Ref. Spiegelberg	Ref. BfArM
CMP-202211001	Fall-Nr. 31936/22

## Urgent Field Safety Notice

For Spiegelberg Probes with tunneling:

Figure 1: left: probeside-connector (1) and securing nut (2); right: finished connection

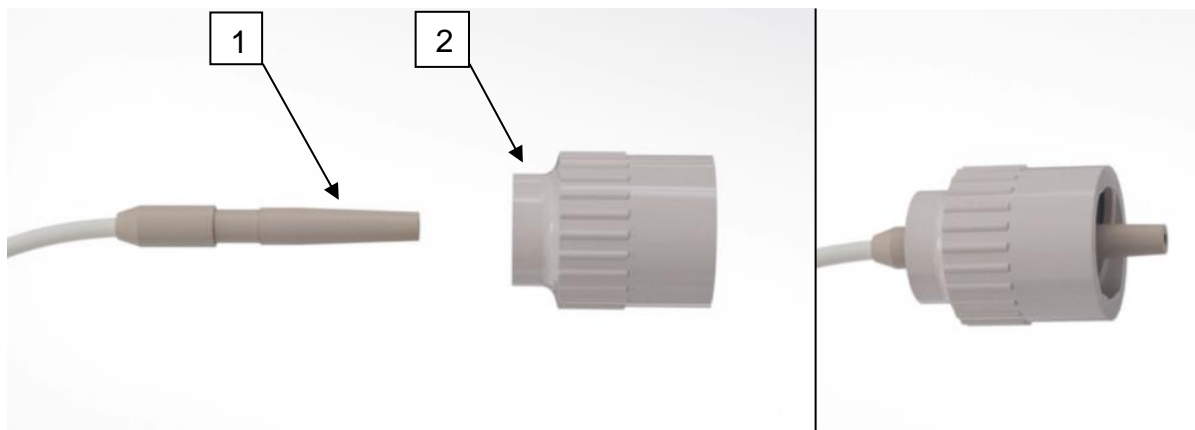
To connect the extension tube, a securing nut (see Figure 1, (2)) is pushed on the probeside-connector (see Figure 1, (1)). The securing nut contains two plates that allow the probeside-connector to snap securely in place inside the securing nut.

Figure 2: Failed connection

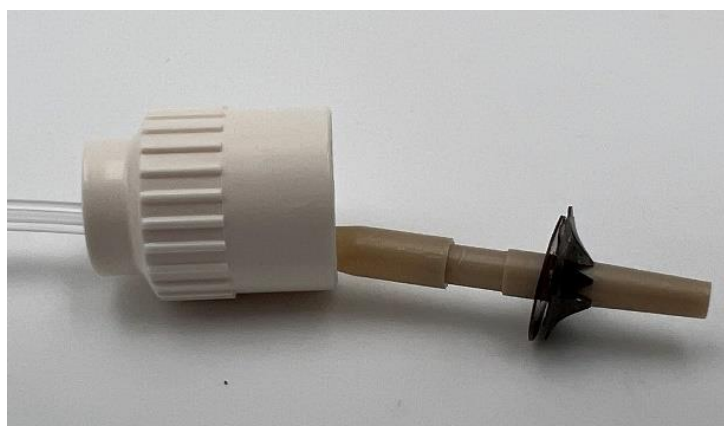
Due to a slowly progressed joining-tool wear, it is possible that the two plates inside the securing nut might break free of the securing nut (see Figure 2).

1. The probe is placed and tunneled. The user tries to make the connection between the securing nut and the probeside-connector. The connection fails (as shown in Figure 2) and cannot be made. The two plates and the securing nut can be removed from the probeside-connector, a new securing nut needs to be used. Therefore, a new product needs to be opened.
2. The probe is placed and tunneled. The user tries to make the connection between the securing nut and the probeside-connector. The connection fails (as shown in Figure 2) and cannot be made. The two plates and securing nut cannot be removed from the probeside-connector, the probe needs to be removed and a new probe must be placed and tunneled.

Upon investigation, it was found that a slowly progressed joining-tool wear, that was not identified within the maintenance process, caused the weakening of the securing nut.

- a. Update of the manufacturing process, tools, and standard operating procedures.
- b. Update of the concerning tool-maintenance process.
- c. Update of the risk assessment.

In order to mitigate the potential risk for the patient, Spiegelberg will provide double packed and sterile security nuts as replacement parts. These security nuts will originate from the updated manufacturing process.
